Report FL #: 10088 for Greenheck models EHH-601D & ESD-635D (both w/ and w/o VCD-40 Damper)

Report FL #: 10093 for Airolite models SCH601MD & K6746MD (both w/ and w/o VCD-40 Damper)

APPROVAL DOCUMENT: Drawing No. **K6746MD**, titled "K6746MD Louver", sheets 1 through 37 of 37, dated 08/09/2017, prepared by The Airolite Company, signed and sealed by Wayne K. Helmila, P.E. on 08/19/2024 and 09/27/2024, bearing the Miami-Dade County Product Control revision stamp with the Notice of Acceptance number and expiration date by the Miami-Dade County Product Control Section.

PRODUCT REVISED
as complying with the Florida
Building Code
NOA-No. **24-0930.05**
Expiration Date **12/06/2029**

AIROLITE SCHOFIELD, WISCONSIN 54476 715-359-6171	DRAWN BY MES	DATE 8/9/2017
	SCALE	
TITLE K6746MD LOUVER CONTINUOUS ANGLE MOUNT MULLION DETAILS WITH END PLATE MOUNTING, HS144"	SHEET NO. 13 OF 37	CAD DRAWING NO. K6746MD

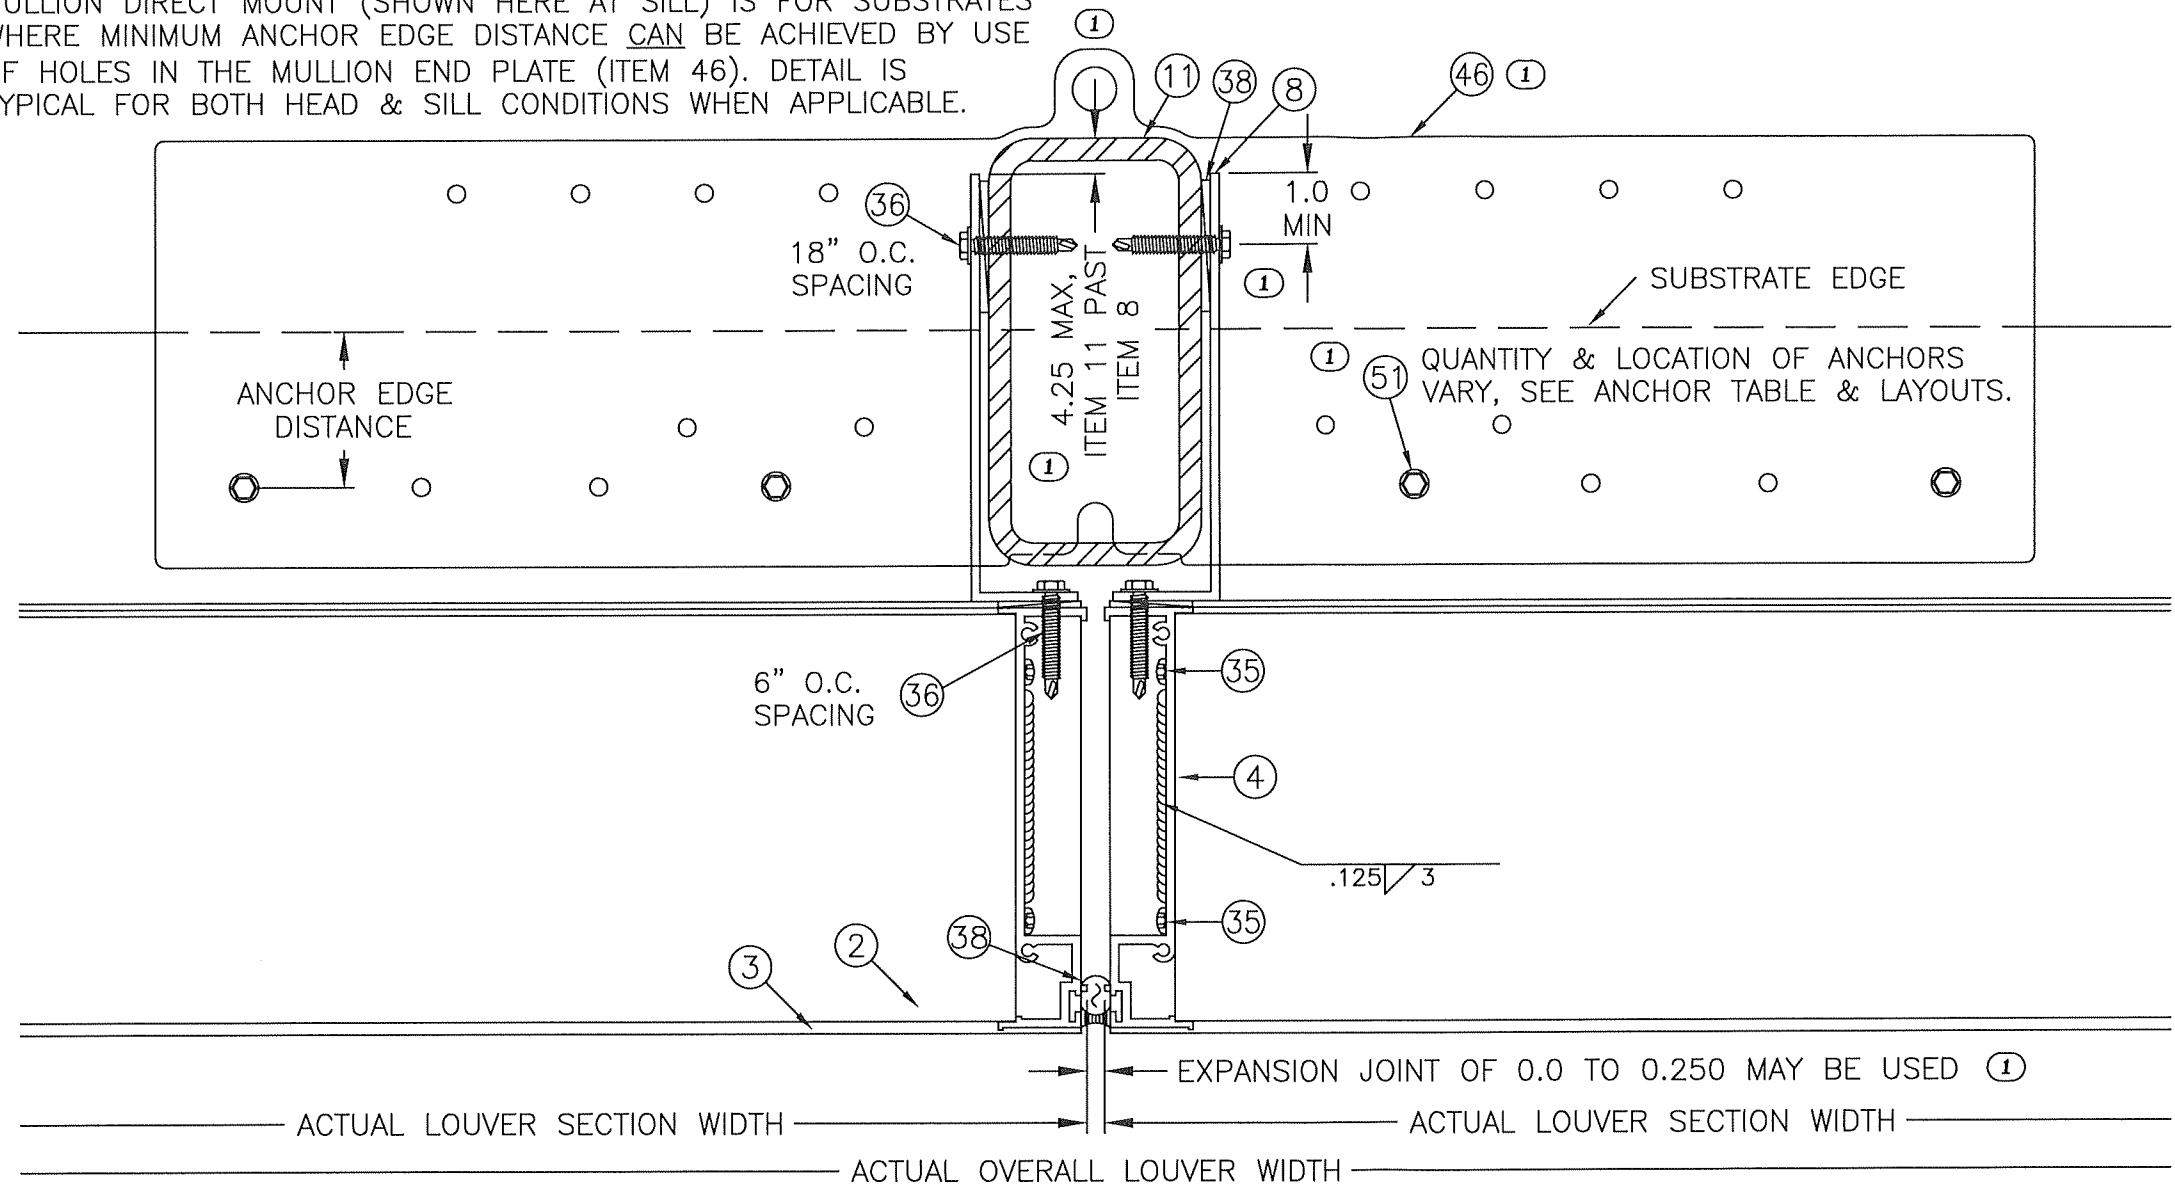
REV 01: 8/1/24, WAS PAGE 12, MOVED DETAIL 16B TO A NEW PAGE, ADDED LIFTING LUG, REPLACED ITEM 46 WITH UPDATED DESIGN, REDEFINED ITEM 11 MAX OFFSET, ADDED 1.0 MIN OFFSET, UPDATED ANCHOR REFERENCE NOTE, & REWORDED MULLION GAP NOTE.

AIROLITE SCHOFIELD, WISCONSIN 54476 715-359-6171	DRAWN BY MES	DATE 8/9/2017
	SCALE	
TITLE K6746MD LOUVER CONTINUOUS ANGLE MOUNT MULLION DETAILS WITH MULLION ANGLE MOUNTING, H ≤ 144 "	SHEET NO. 14 OF 37	
	CAD DRAWING NO. K6746MD

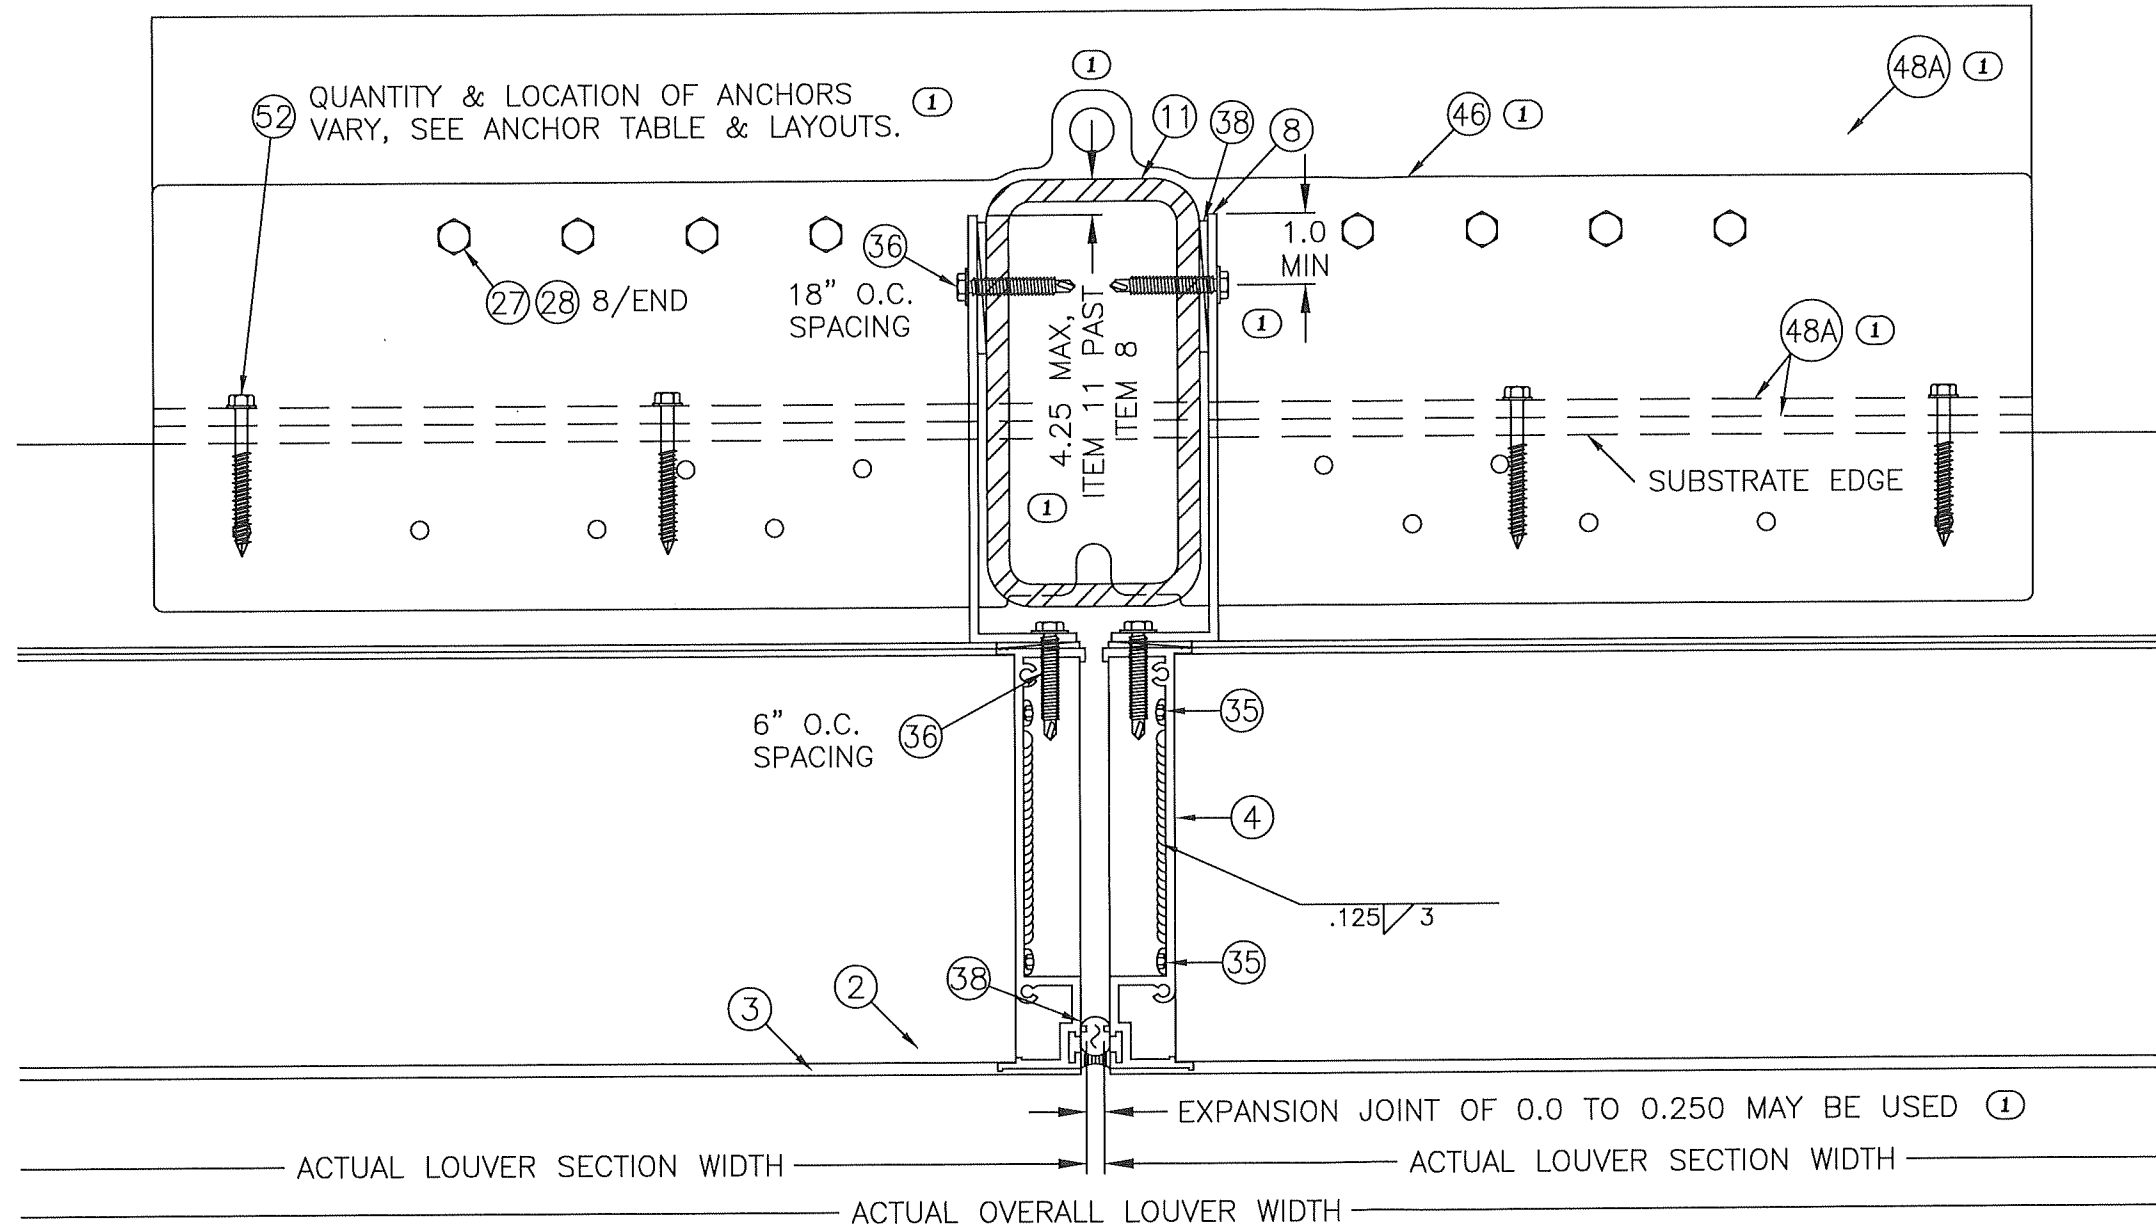
REV 01: 8/1/24, MOVED DETAIL 16B TO THIS NEW PAGE, ADDED
LIFTING LUG, REPLACED ITEMS 46 & 48A WITH UPDATED DESIGNS,
REDEFINED ITEM 11 OFFSET, ADDED 1.0 MIN OFFSET, UPDATED
ANCHOR REFERENCE NOTE, & REWORDED MULLION GAP NOTE.

MULLION DETAIL, W/ END PLATE MOUNTING
LOUVER HEIGHT $\leq$ 96 IN.

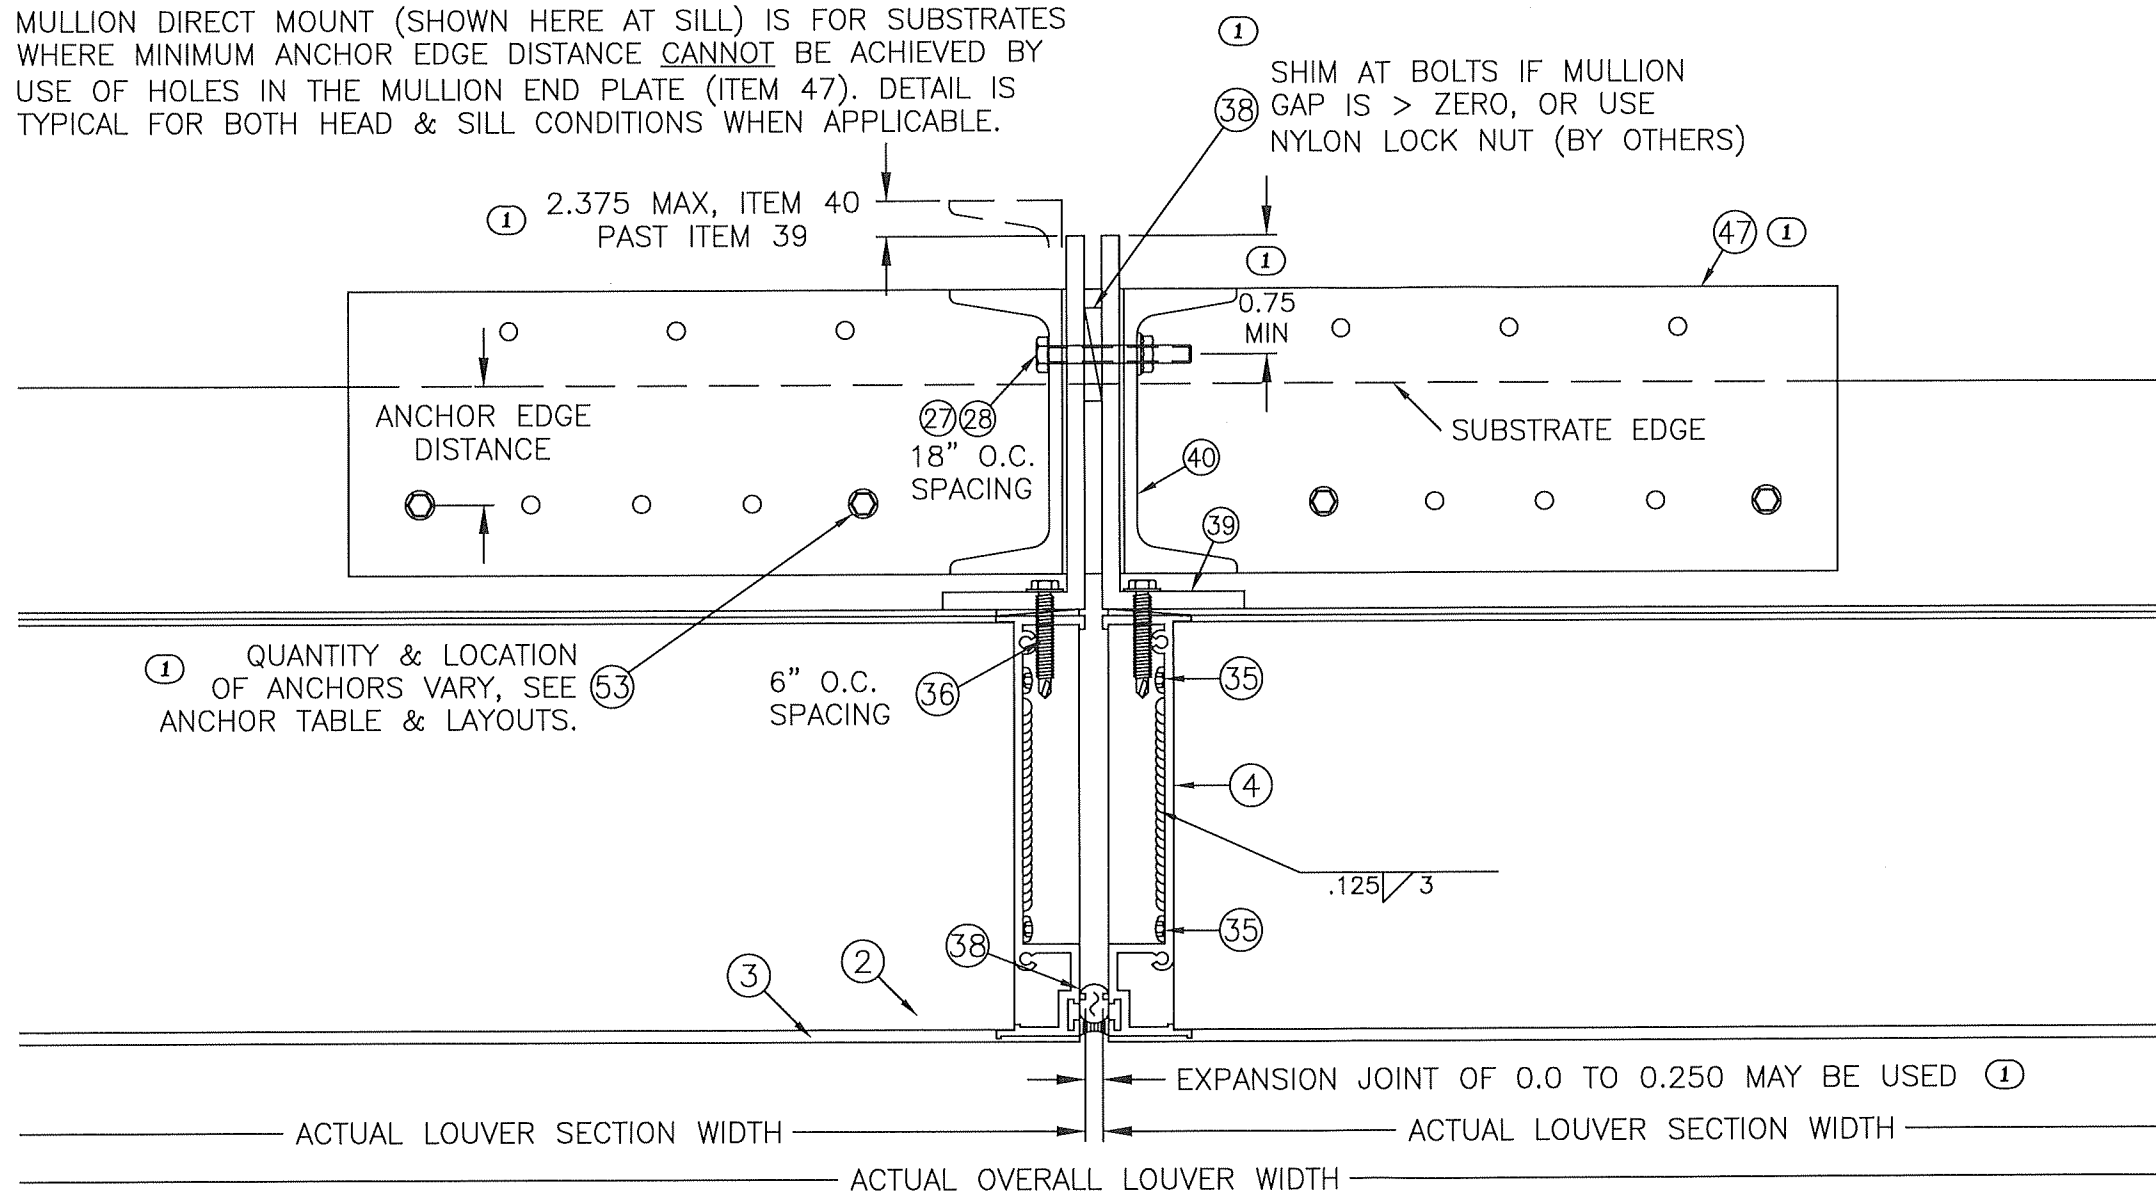
REV 01: 8/1/24, WAS PAGE 13, MOVED DETAIL 17B TO A NEW PAGE, REPLACED ITEM 47 WITH UPDATED DESIGN, REDEFINED ITEM 40 MAX OFFSET, ADDED 0.75 MIN OFFSET, ADDED ITEM 38 & NOTE, UPDATED ANCHOR REFERENCE NOTE, & REWORDED MULLION GAP NOTE.

AIROLITE SCHOFIELD, WISCONSIN 54476 715-359-6171	DRAWN BY MES	DATE 8/9/2017
	SCALE	
TITLE K6746MD LOUVER CONTINUOUS ANGLE MOUNT MULLION DETAILS WITH MULLION ANGLE MOUNTING, H $\leq$ 96"	SHEET NO. 16 OF 37	
	CAD DRAWING NO. K6746MD

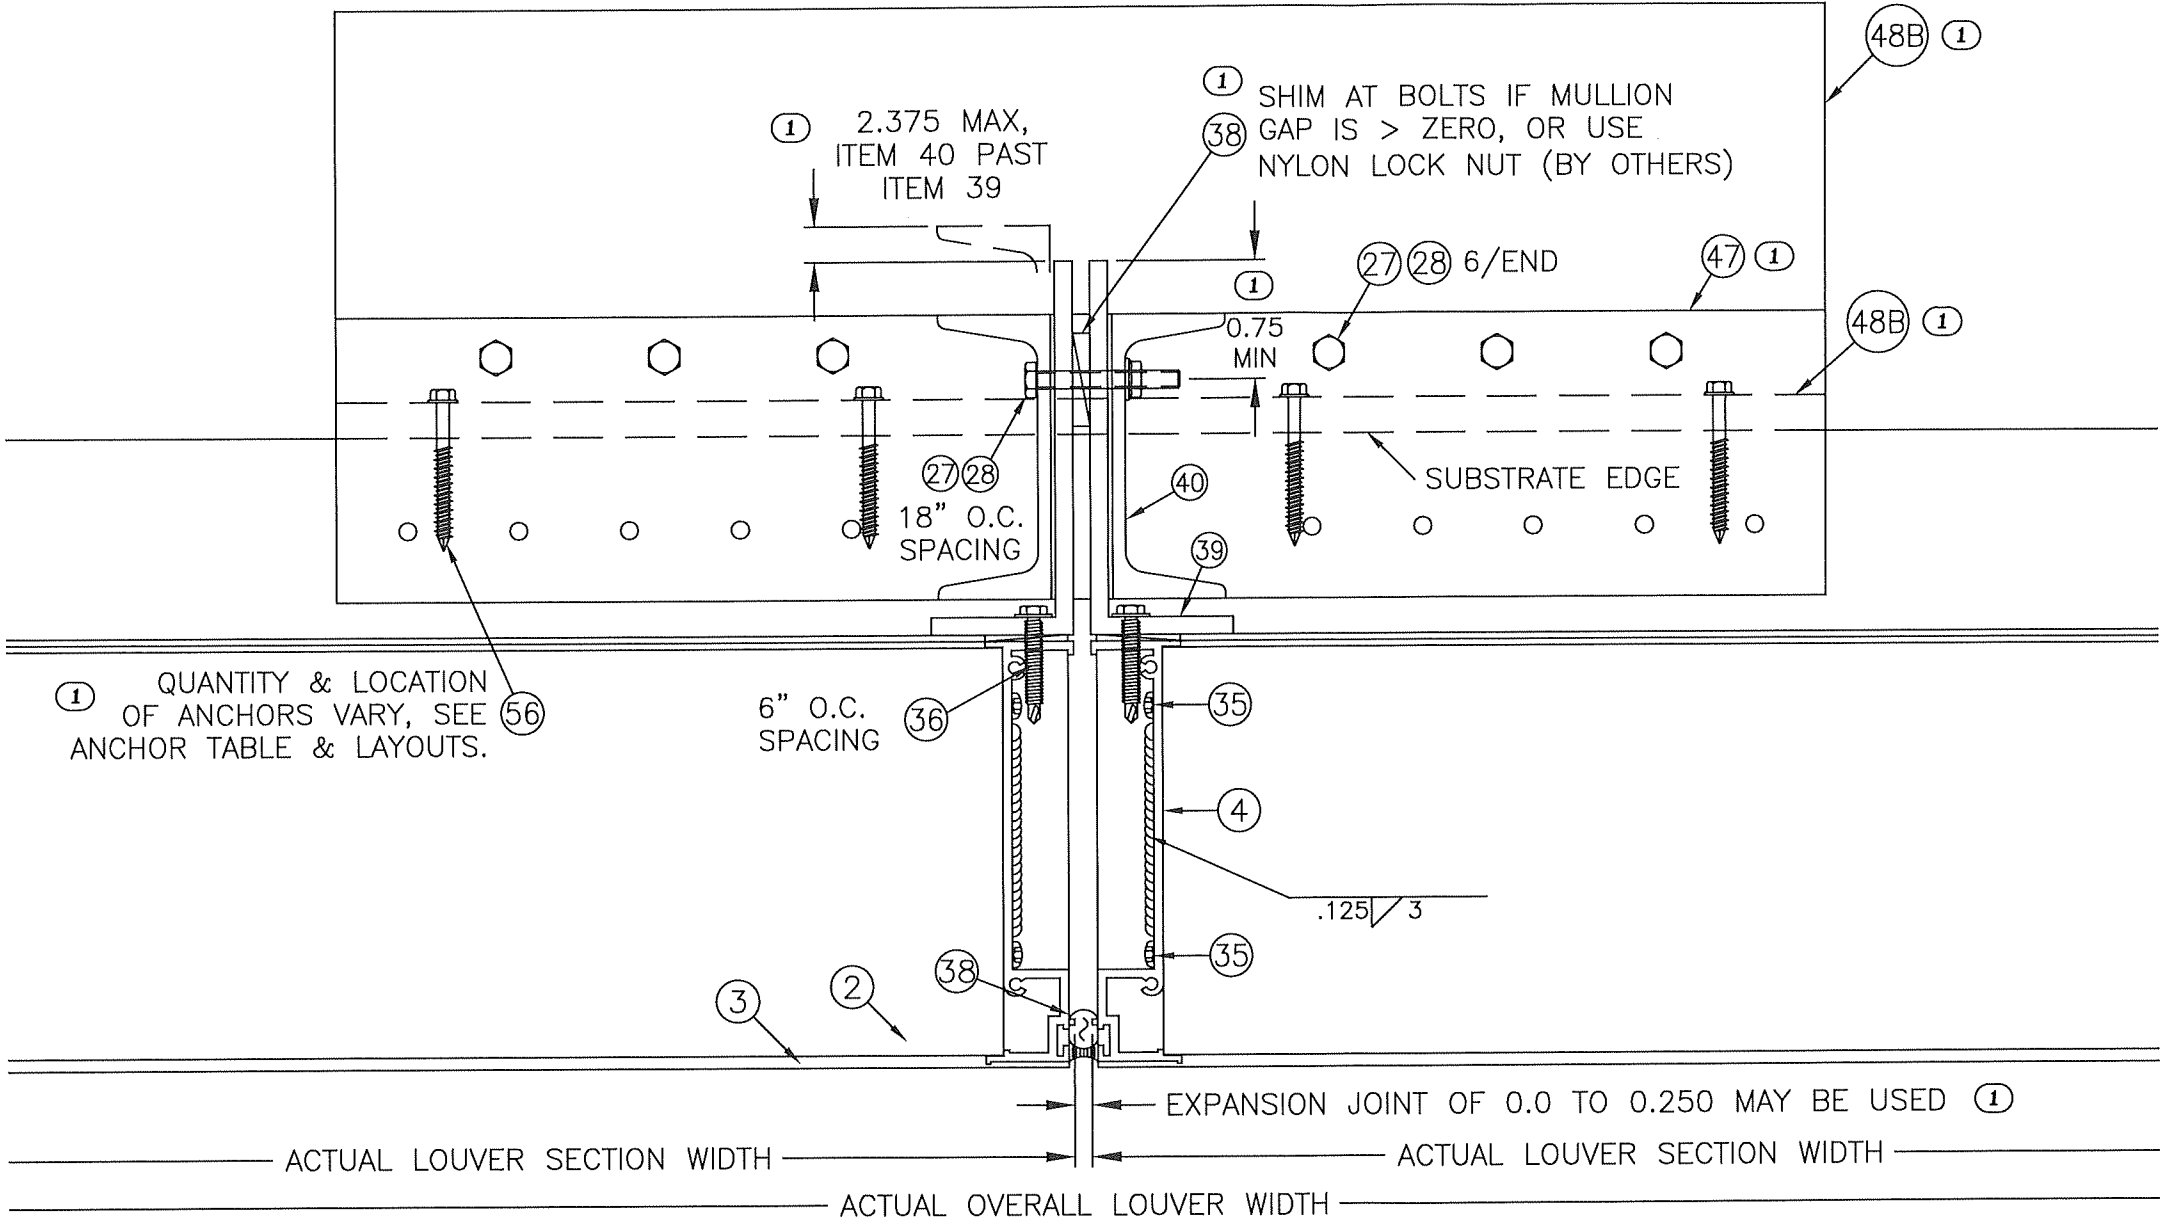
REV 01: 8/1/24, MOVED DETAIL 17B TO THIS NEW PAGE, REPLACED
ITEMS 47 & 48B WITH UPDATED DESIGNS, REDEFINED ITEM 40 MAX
OFFSET, ADDED 0.75 MIN OFFSET, ADDED ITEM 38 & NOTE, UPDATED
ANCHOR REFERENCE NOTE, & REWORDED MULLION GAP NOTE.
